RE: NVS-213aan, PE08-029

EF CROSSMEMBER DESIGN CHANGE (EO NO: N3830284)

☐ EF CROSSMEMBER PRODUCTION AND COATING PROCEDURE CHANGE

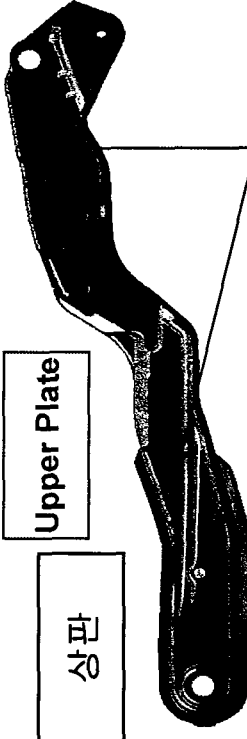
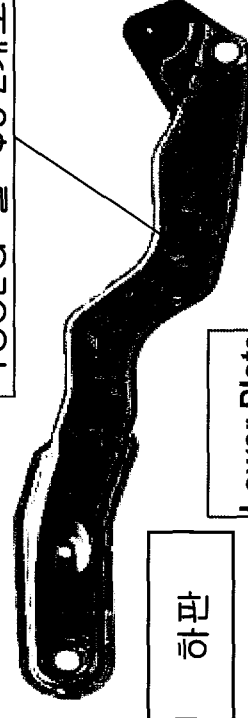
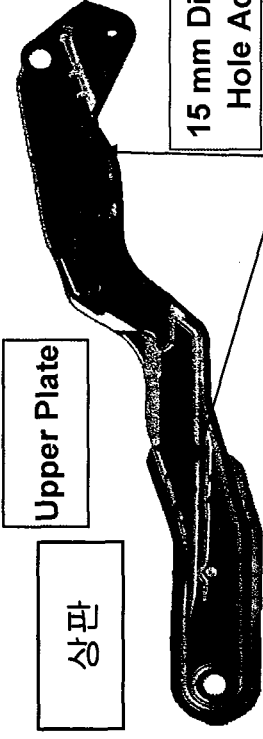
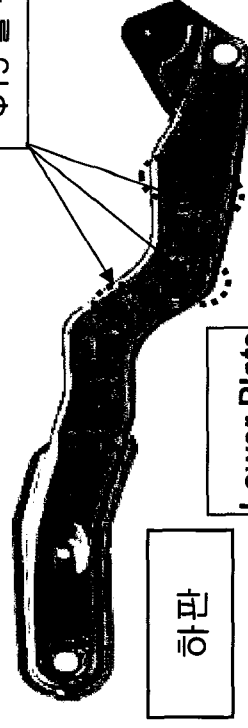
Original 개	선	선	후
<div> <div>상판</div> <div>Upper Plate</div>  </div> <div> <div>하판</div> <div>Lower Plate</div>  </div> <div> 도료유입 및 드레인 홀 없음 *TOOL'G 홀 $\phi 5$ 2개소 있음 </div> <div> No Drain Hole or Hole for Paint Application 2 Tooling Holes of 5 mm Diameter </div>		<div> <div>상판</div> <div>Upper Plate</div>  </div> <div> <div>하판</div> <div>Lower Plate</div>  </div> <div> 15 mm Diameter Hole Added $\phi 15$ 홀 추가 $\phi 12$ 홀 추가 12 mm Diameter Hole Added </div>	
<div>개선 내용</div> <div>Description of Improvement</div>	<div> ▲ CROSSMEMBER 도료 유입 홀 추가 및 도막 두께 증대 ('03.11.20) - 도료유입 및 드레인 홀 추가 : $\phi 15$ 홀 5개소, $\phi 12$ 홀 1개소 Added Holes in Crossmember for Paint Application and Increased Thickness of Paint (11/20/2003) - Add 5 Holes of 15 mm Diameter and 1 Hole of 12 mm Diameter </div>

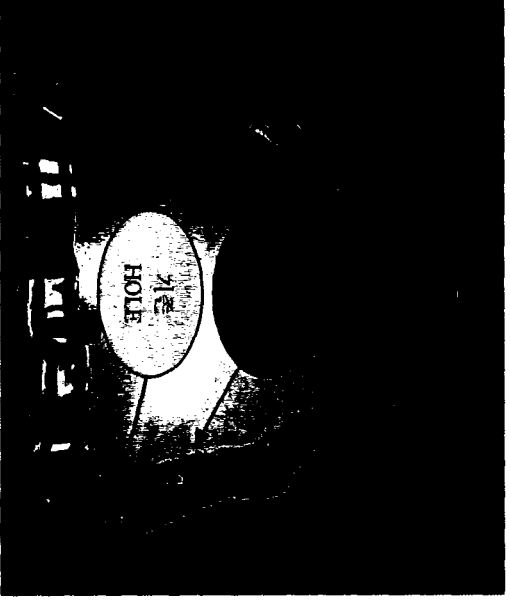
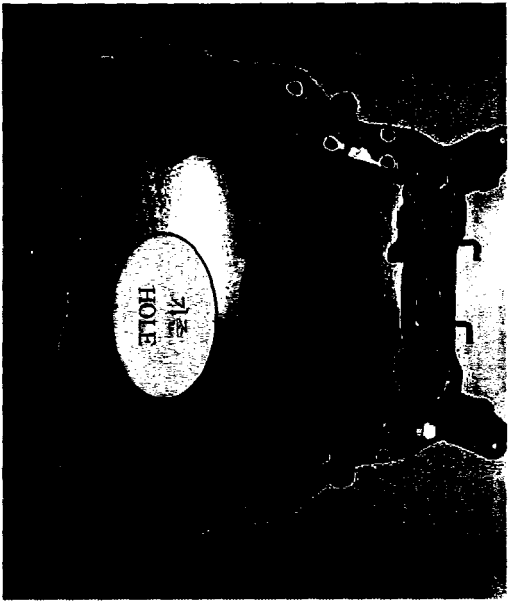
구분	일자	변경내용	비고
생산공정	2003.11.20	- C/MBR S/MBR 드레인 홀 추가 : 12EA (UPR : $\Phi 15 - 4EA$, LWR : $\Phi 12 - 4EA$, $\Phi 15 - 4EA$)	
도장공정	2003. 9월	- 전처리 탕세공정 신설 - 표면조정공정 개선 (스프레이→딤핑)

LINE	DATE	DESCRIPTION OF CHANGE	REMARK
ASSEMBLY LINE	11/20/2003	- CROSSMEMBER AND SIDEMEMBR ADDDED 12 DRAIN HOLES EACH (UPPER : $\Phi 15 \text{ mm} - 4EA$, LOWER : $\Phi 12 \text{ mm} - 4EA$, $\Phi 15 \text{ mm} - 4EA$)	
PAINT LINE	9/2003	- ADDED CLEANING PROCESS - CHANGED CLEANING PROCESS (FROM SPRAY→DIPPING)

DESCRIPTION OF CROSSMEMBER DRAIN HOLE IMPROVEMENT

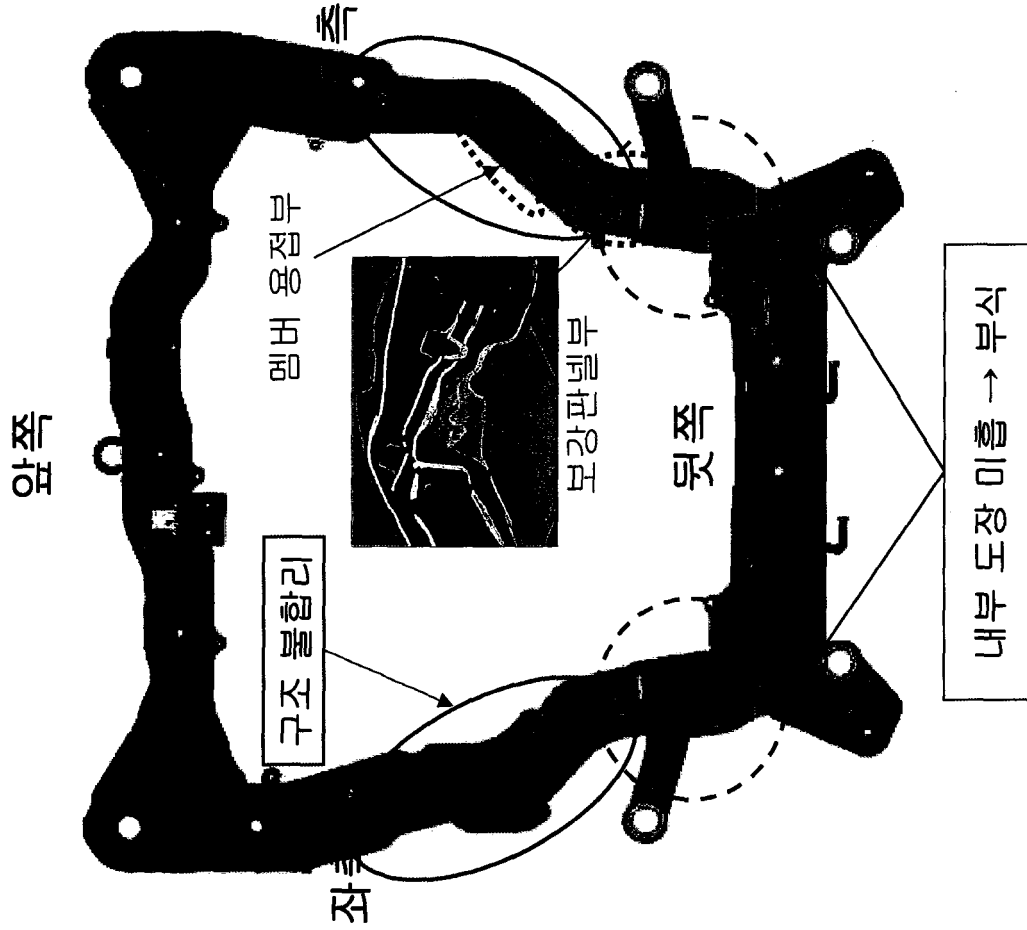
BEFORE AND AFTER	UPPER PANEL	LOWER PANEL	NUMBER OF HOLES
구분	UPR PNL	LWR PNL	HOLE 개수
<div data-bbox="943 201 984 317">개선前</div> <div data-bbox="839 191 880 348">ORIGINAL</div>			<div data-bbox="1075 1745 1149 1923">ORIGINAL HOLES</div> <div data-bbox="885 1724 1050 1923"> 기존 HOLE UPR 2EA LWR 2EA (TOOL'G HOLE) </div>
<div data-bbox="376 201 417 317">개선後</div> <div data-bbox="261 180 335 348">COUNTER MEASURE</div>			<div data-bbox="563 1745 654 1923">ORIGINAL HOLES</div> <div data-bbox="265 1745 538 1913"> 기존 HOLE UPR 2EA LWR 2EA 추가 HOLE UPR 4EA LWR 8EA </div> <div data-bbox="142 1755 241 1913">  </div>
